| Request | - | Major Site Plan Review for Swayne Field Shopping Center Renovation |
| Location | - | 3054 Monroe Street |

MAJOR SITE PLAN REVIEW
TOLEDO PLAN COMMISSION
REF: SPR25-0016
DATE: July 3, 2025
TIME: 2:00 P.M.

SITE PLAN

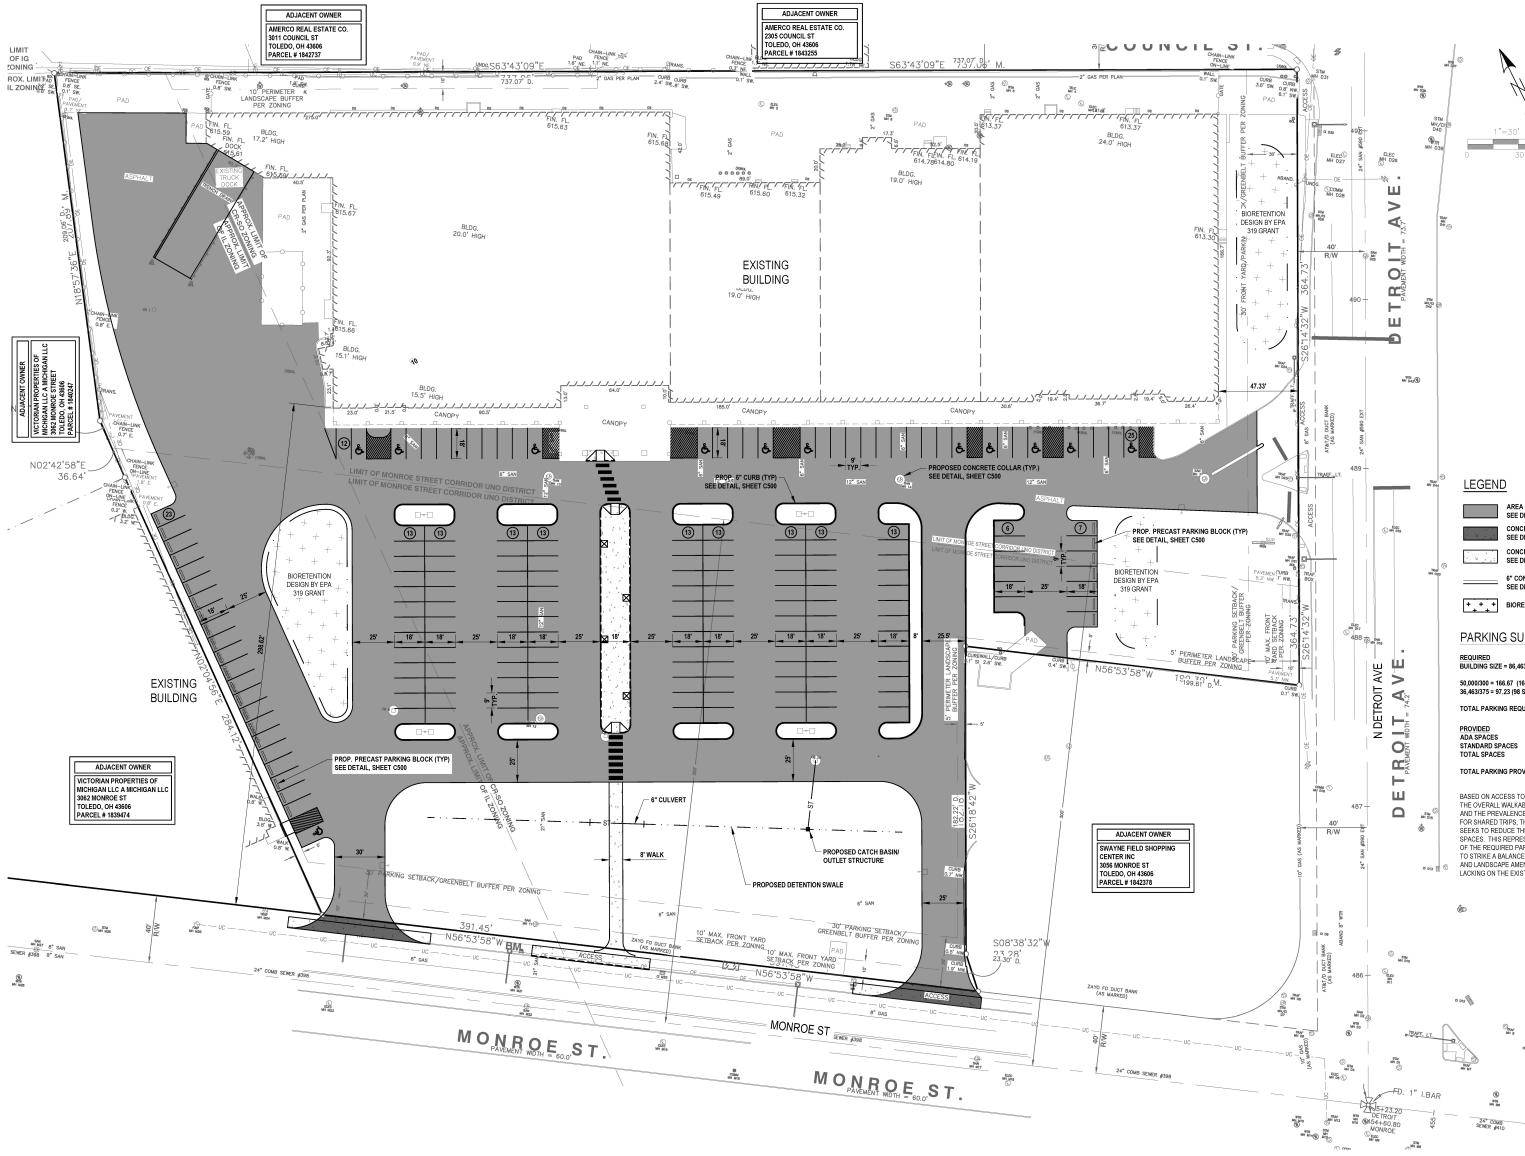
22. One (1) bicycle parking space is required per ten (10) vehicle parking spaces. Bicycle parking spaces shall be compliant with TMC§1107.0900. **Not acceptable as depicted. A revised site plan shall be submitted to the Planning Director depicting a minimum of nineteen (19) bicycle parking spaces.**

24. A hedge row or masonry wall shall be installed between Detroit Avenue and the bioretention area depicted on the site plan so that no headlights of any vehicles can be seen from the public street. **Not acceptable as depicted. A revised site plan shall be submitted to the Planning Director.**

31. A continuous internal pedestrian connecting walkway is required between Detroit Avenue and the walkway along the front of the principal building in compliance with TMC§1109.0304. **A revised site plan shall be submitted to the Planning Director depicting this walkway.**

LANDSCAPE PLAN

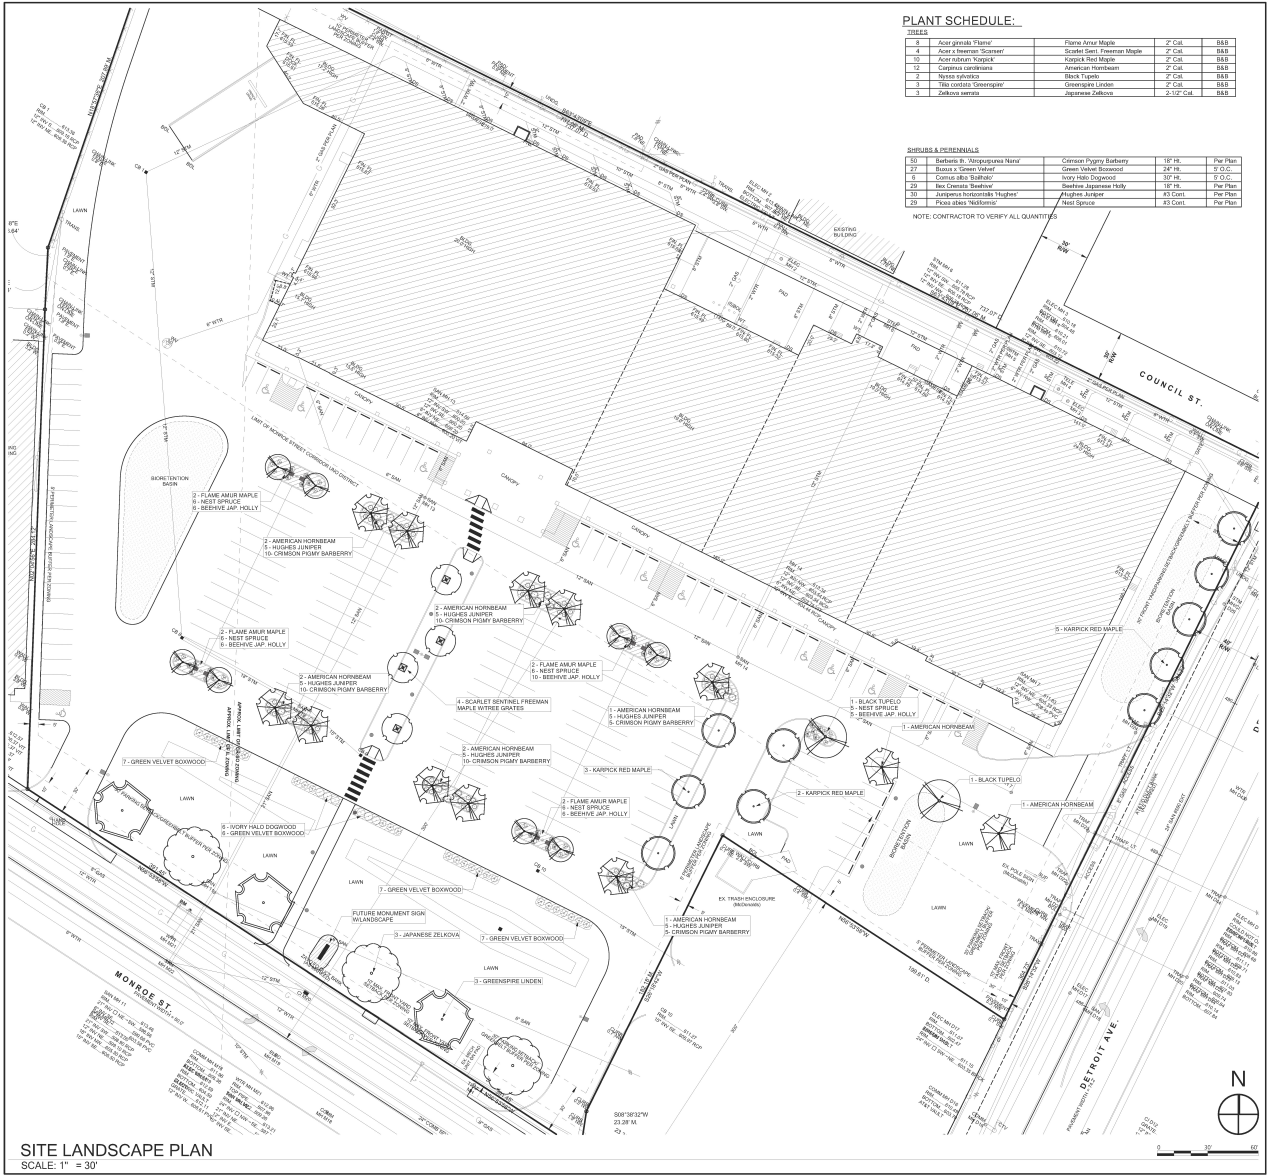
TMC§1108.0202 *Frontage Greenbelt* requires landscaped greenbelts along public rights-of-way. At least one (1) tree would be required within this greenbelt for every thirty feet (30’) of lot frontage. TMC§1108.0202 would require thirteen (13) trees in the Monroe Street greenbelt. The applicant has provided six (6) trees on the submitted landscape plan and asked that this reduced number of trees be permitted due to limited planting areas and to allow greater storefront visibility. The Planning Director has determined that this is acceptable due to the characteristics of the proposed improvements.

TMC§1108.0202 would also require thirteen (13) trees along the Detroit Avenue greenbelt. The applicant has provided five (5) trees on the submitted landscape plan and asked that this reduced number of trees be permitted due to existing driveways and the existing McDonald’s sign. The Planning Director has determined that this is acceptable due to the characteristics of the proposed improvements.

Based on the number of proposed parking spaces, TMC§1108.0204 *Parking lot Landscaping* would require the parking area to include 3,800 square feet of landscaped area with a minimum of thirty-eight (38) trees and one-hundred-fourteen (114) shrubs. The submitted landscape plan provides 3,984 square feet of landscaped area with thirty-one (31) trees and one-hundred-thirty-eight (138) shrubs. The Planning Director has determined that this is acceptable due to the characteristics of the proposed improvements.

Based upon the size of the building, TMC§1108.0205 *Interior Site Landscaping* would require that the site include eighty-six (86) trees on top of other landscaping requirements along with foundation plantings. No additional trees or foundation plantings are proposed on the submitted site plan. The Planning Director has determined that this is acceptable due to the characteristics of the proposed improvements.

EAST & NORTH ELEVATIONS

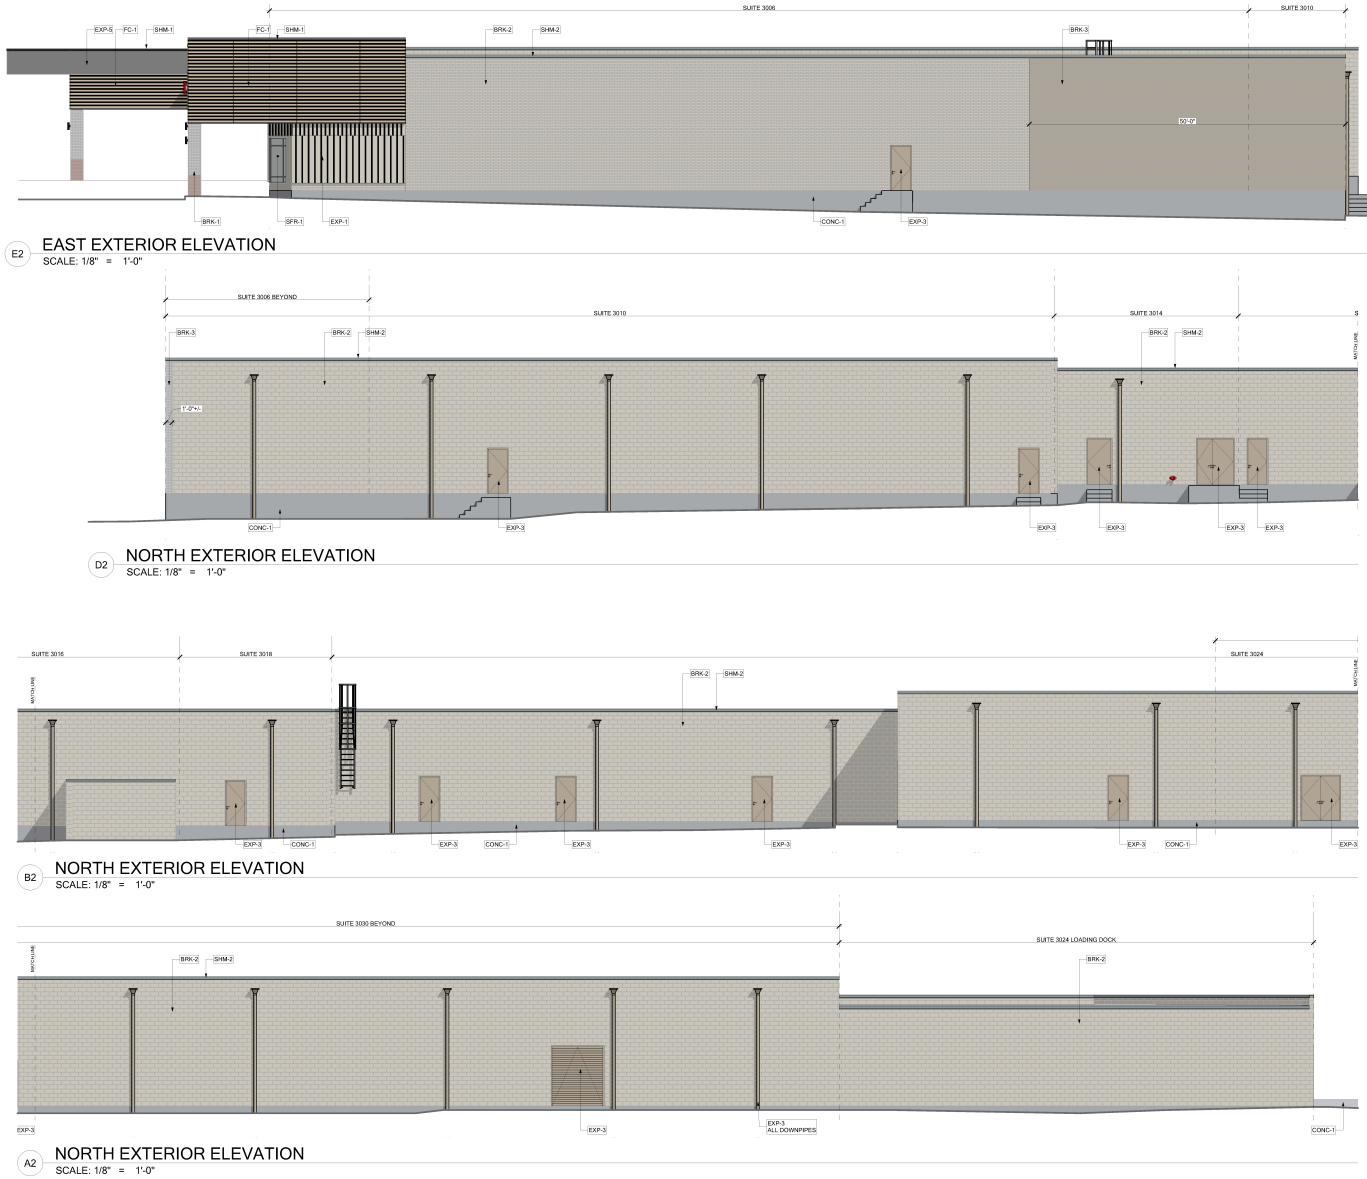
TMC§1109.0906(D) prohibits Exterior Insulation and Finish Systems (EIFS) materials within the Monroe Street Corridor UNO District. The submitted elevations show 16.7% of the Monroe Street elevation will be comprised of EIFS; however, the applicant's architect has clarified that the proposed modifications do not include the addition of any EIFS materials nor are there existing EIFS exterior finishes. Revised elevations shall be submitted to the Plan Director reflecting no exterior EIFS materials in compliance with TMC§1109.0906(D). This has been included as a condition of approval.

30. Exterior insulation and finish system (EIFS) materials and applications are prohibited per TMC§1103.0906(D). **Revised elevation drawings shall be submitted to the Planning Director depicting no EIFS materials on exterior elevations.**
